Case number: **2020-002483-HDRB**
Project Type: **HDRB**

PROJECT LOCATION (S): **524 Calle Corvo**

DATE: November 24, 2020
TO: Historic Districts Review Board Members
FROM: Daniel Schwab, Senior Planner, Historic Preservation Division

Case # 2020-2483-HDRB

Wall design symmetry

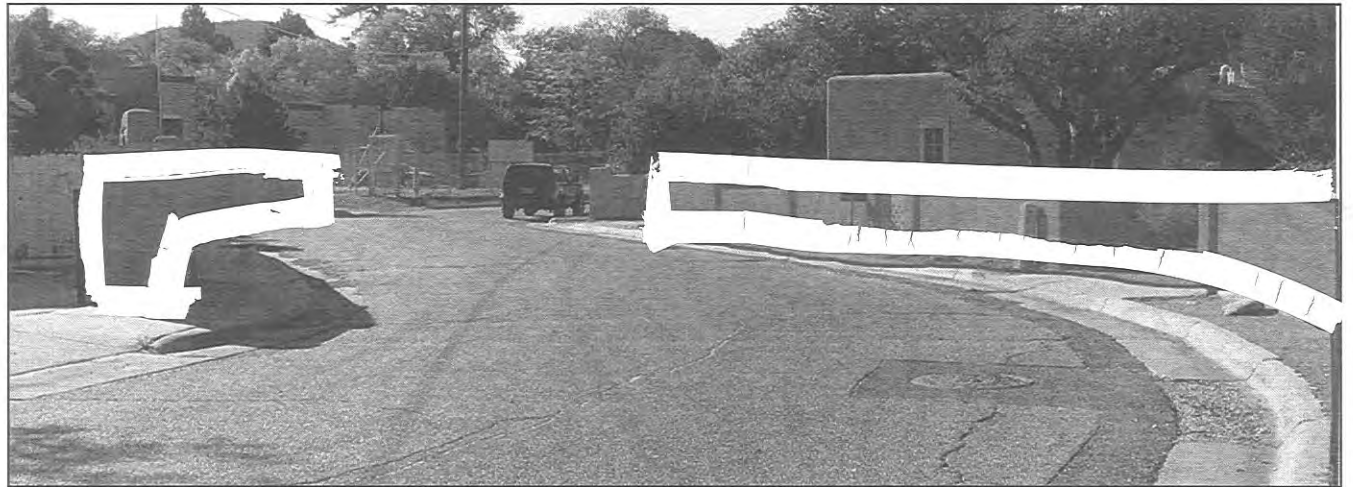
The street yard wall has a historic status of contributing. It has a unique design that takes up the full width of the view as one moves through the subdivision and is complemented by a very

similar wall directly opposite, on the opposite side of the street. The design is defined by a *vertical symmetry* which is higher at the ends, with rhythmic divisions descending to an opening at the center. Staff does not agree with the applicant that there is a “theme of stepping the wall down as the street moves north.” It is the opinion of Staff is that a 12-foot wide opening will fundamentally disrupt the integrity of this overall vertically symmetrical design which is unique within the context of the district, as is the development of the Hughes Subdivision itself.

The character of the district is preserved by retaining historic material, preserving historic status, and retaining an accurate sense of history. The proposal undermines the character of the district by removing historic material, threatening the contributing status of the wall and creating a false sense of history in the form of a yard-wall that steps down toward the north.

The proposed design disrupts the vertical symmetry of the yard wall, thus damaging the character of the district where walls that are congruent with the original design of the house, the lot, and the design intention of the subdivision are found in the Downtown and Eastside;

DESIGN OPTION 'A' - PROPOSED GARAGE USING EXISTING DRIVEWAY ACCESS

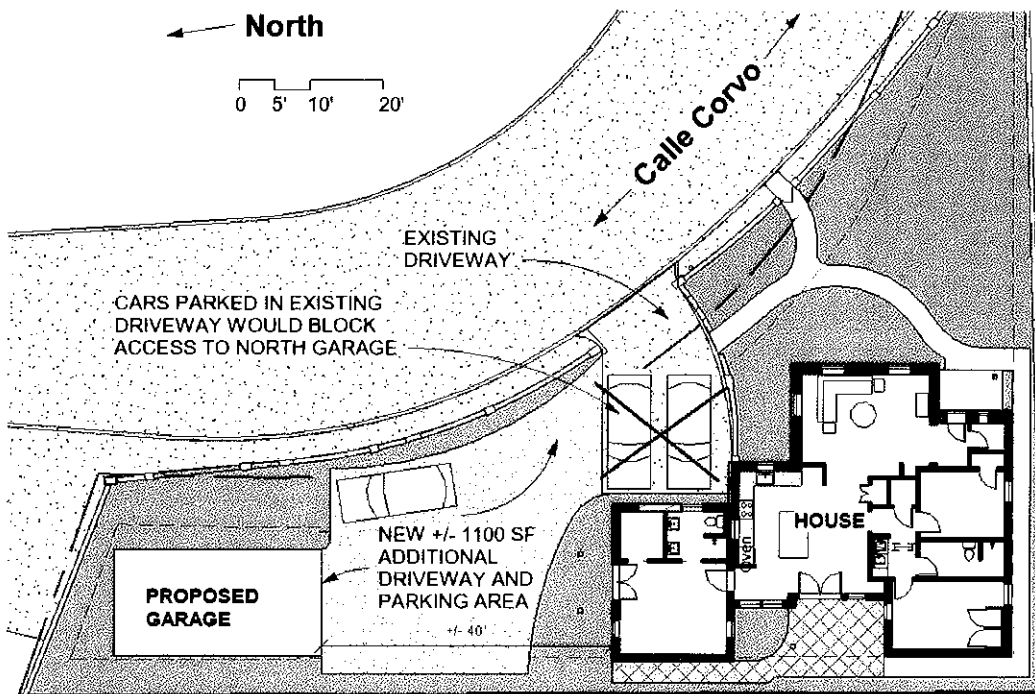
Staff Response: The applicant has asserted that two hardships will arise from not being granted an exception:

a) It would require the creation of a turnaround space which would eliminate two parking spaces that now exist that would need to be used for circulation instead.

b) The distance from the garage to the house would be increased from 15 feet in the proposed design to forty feet.

Staff finds that these hardships are created by the proposed design. There exists no need for an automobile turn-around on the property of a single-family home that warrants partial demolition of a historic structure. Walking 40 feet instead of 15 feet does not threaten the health or safety of the applicant or the general public, which Staff regards as basis for an exception.

The need to have a turn around or a decrease in distance between the detached garage and the house do not constitute a hardship typical of those that warrant an exception by the Board; and

**EXISTING WALL
ELEVATION - Street View**

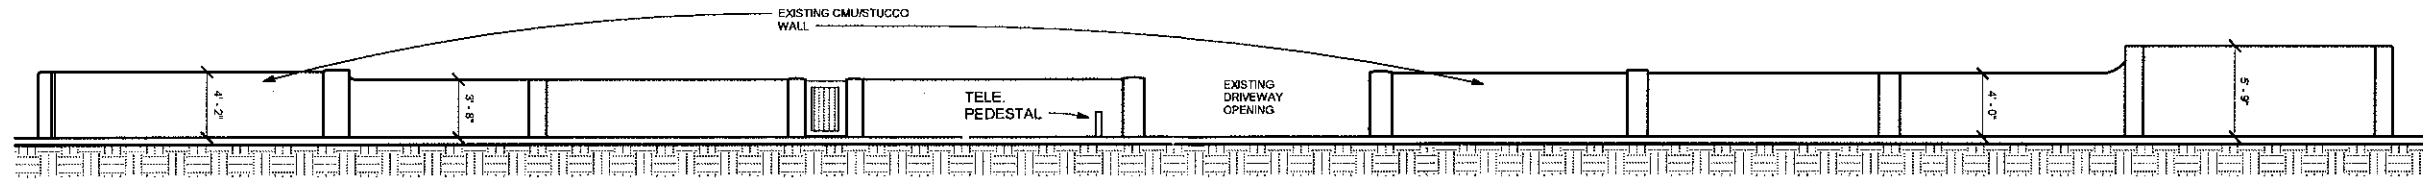
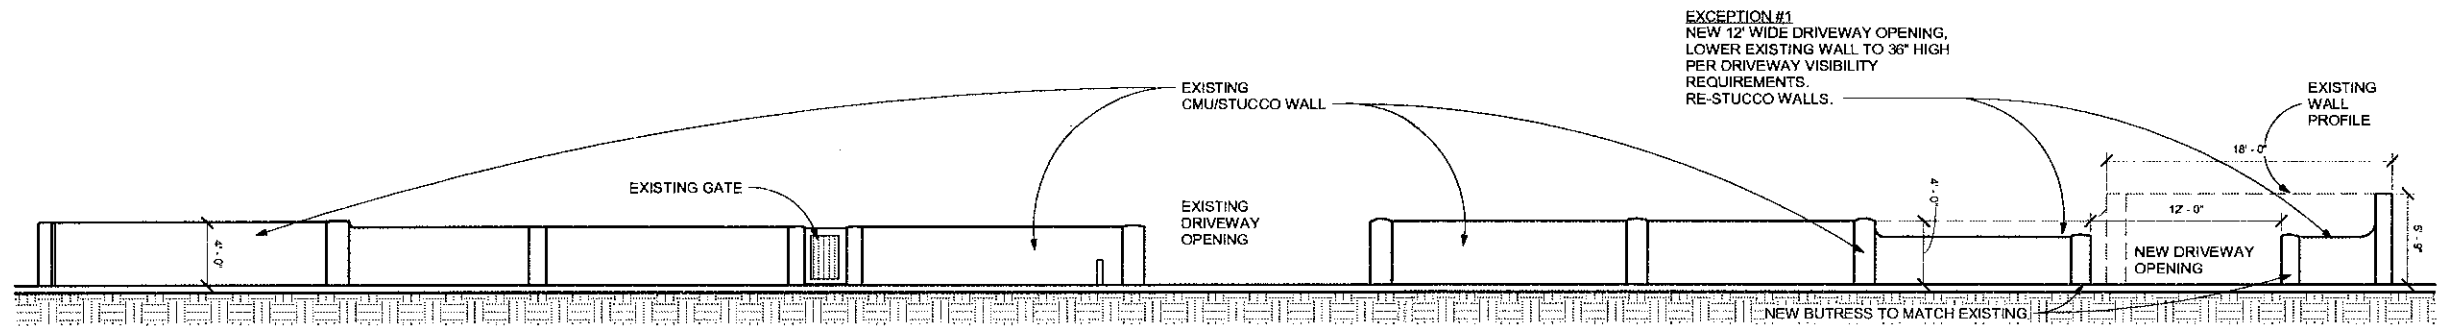
7. Create new 12 foot wide driveway opening in the north portion of the existing Contributing street yard wall to serve as access to the proposed driveway. This item requires an exception to section 14-5.2(D)(1)(a).
8. Re-pave the existing driveway with concrete brick pavers and create new patio areas, one to the north of the house of 120 square feet, one to the west, including the new portal of 160 square feet.

Exception to Section 14-5.2(D)(1)(a): Applicant requests an exception to remove historic material from the Contributing yard wall along the curve of the street.

Staff does not agree with this response.
